**PD Modification Application: MM 26-0551**

Zoning Hearing Master Date: May 26, 2026

**1.0 APPLICATION SUMMARY**

MM 26-0551 is a Major Modification request to PD 06-1564 for the properties at 15120 Livingston Avenue and the adjoining parcel on Sinclair Hills Road covering Folios 34476.0000 and 34497.0000 and approximately 0.86 acres. The PD consists of four platted lots – Lots 1 and 20 along the north fronting Sinclair Hills Road, and Lots 2, 3, and 4 to the south along Livingston Avenue. Lots 2-4 permits limited CN uses, and a currently developed with single-family residential. The request proposes to modify Lots 1 and 20 to allow restricted CN-level commercial, Professional Services, and Health Practitioner uses while removing the previously proposed personal service commercial uses. The modification also introduces enhanced buffering and screening—intended to mitigate potential impacts to adjacent residential properties—along with limited buffer reductions where constrained by existing site conditions.

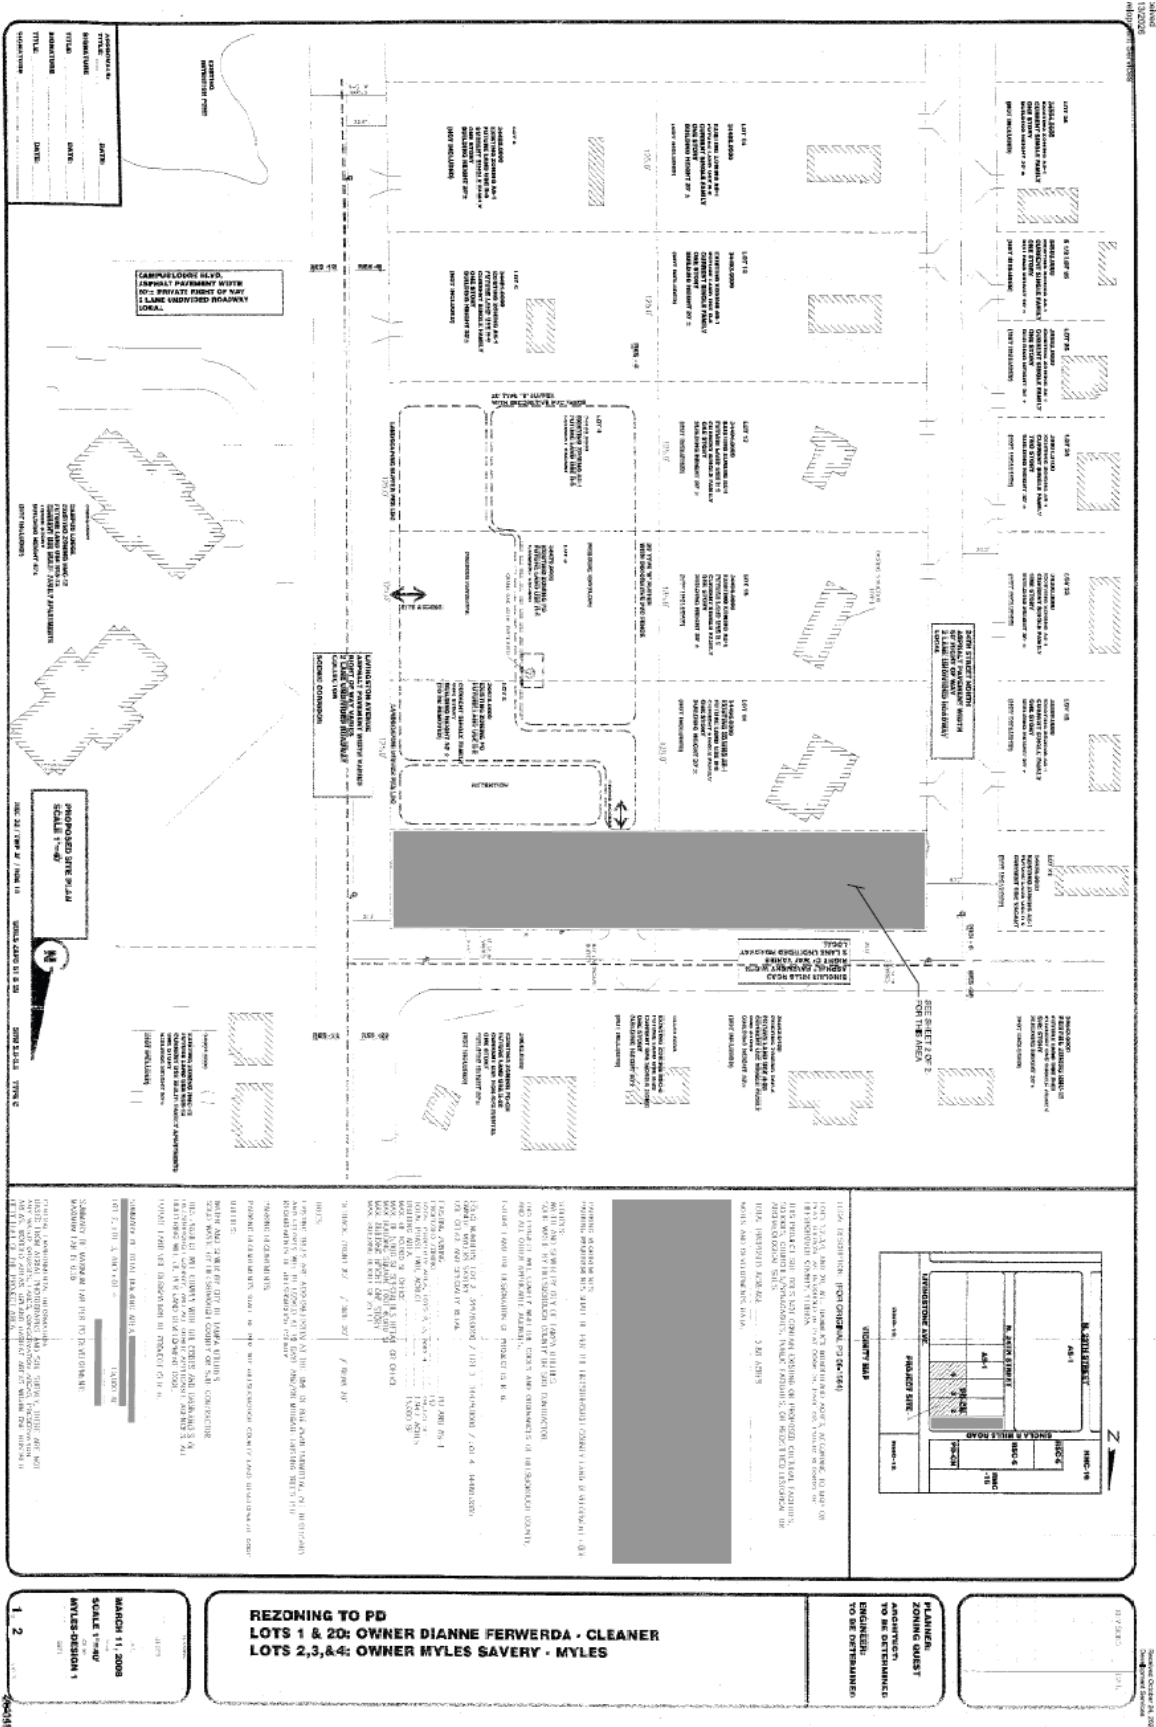
- (c) The proposed access location would provide reasonable access for the proposed Zoning Modification. Without access, the proposed future use of the parcel is not feasible.

- \_\_\_\_\_ Approved
- \_\_\_\_\_ Approved with Conditions
- \_\_\_\_\_ Disapproved

EXHIBIT A, 1 OF 2

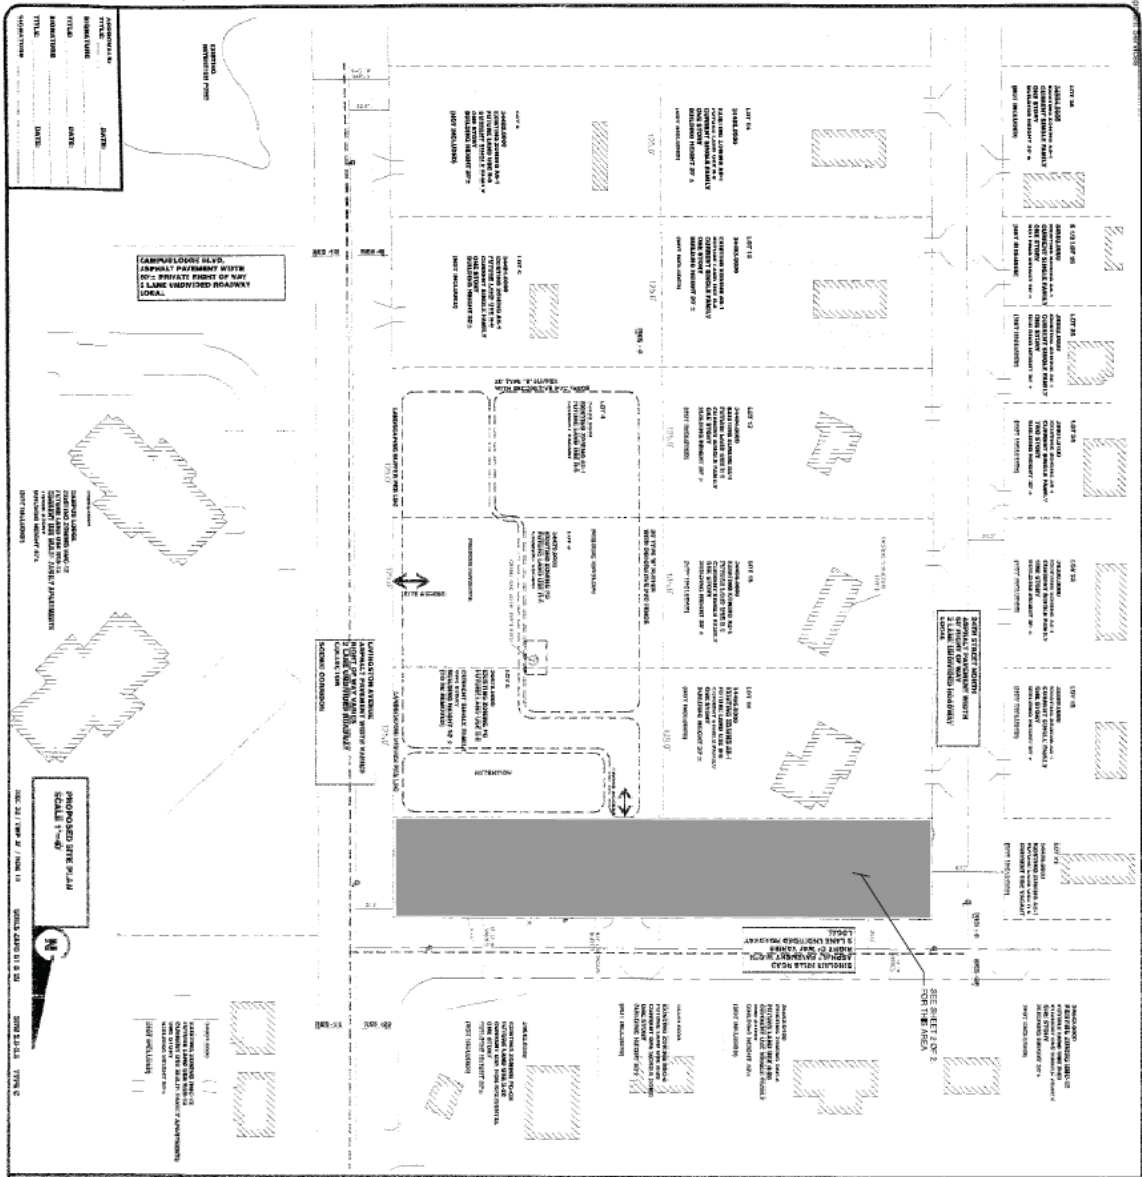
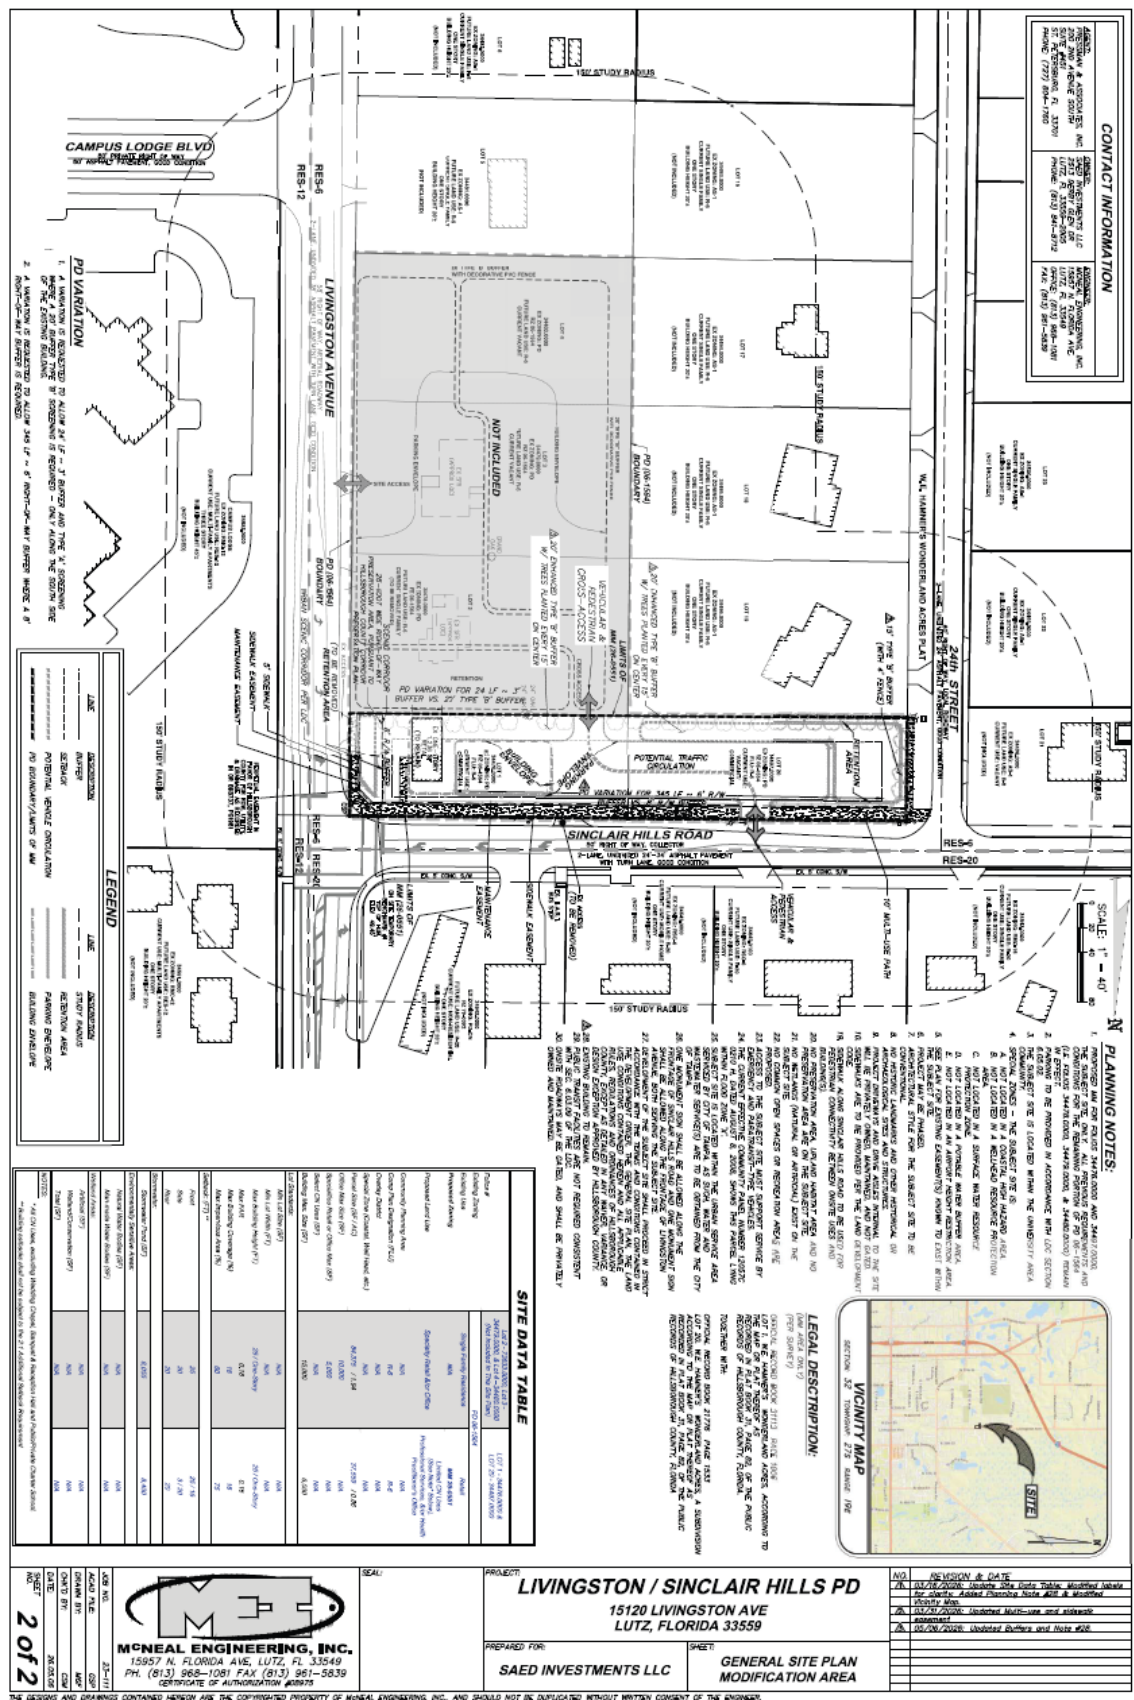
The adjacent site - located within the same PD 06-1564 but outside the MM 26-0551 project area - is approved for 10k SF General Office & 5k SF Retail. The primary access to the adjacent site is on Livingston Avenue with cross access through the project site. Reference the General Site Plan, [Exhibit A](#).

**EXHIBIT C**

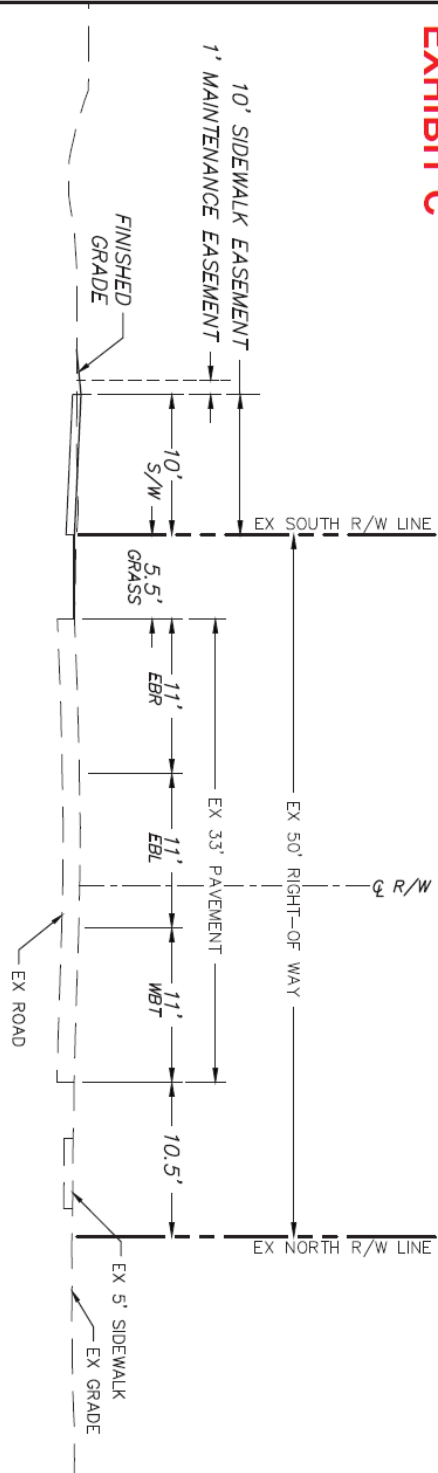
- As Sinclair Hills Rd. is a substandard collector roadway, the developer shall make certain improvements to Sinclair Hills Rd. (along the project's frontage) consistent with the Design Exception request (dated May 5, 2026) and which was found approvable by the County Engineer (on May 14, 2026). Specifically, the developer shall:

- Construct a 10-foot-wide multi-purpose pathway along the south side of Sinclair Hills Rd.;
  - Dedicate and convey to Hillsborough County an +/- 11-foot-wide easement (for public access and maintenance purposes).
